JUVENILE JUSTICE BOARD - II

1, Feroz Shah Kotla Ground, Delhi Gate, New Delhi-110002 (ANNEXURE NO. 1)

NIPMAN FOUNDATION

Access Audit Team

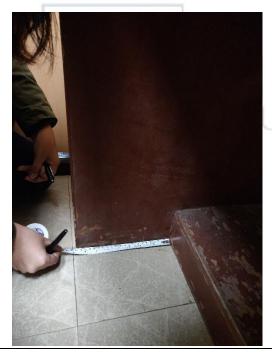
OBSERVATIONS:

- The entrance leading to the clerk's table is 29" wide
- The clerk's table is 30" high
- The presence of foot rest is an obstruction
- The foot rest is 8.5" deep
- Presence of knee space

- The ideal width of the entrance should be 35.5"
- A clear knee space of at least 35" width, 19" depth and 25.5" height should be provided
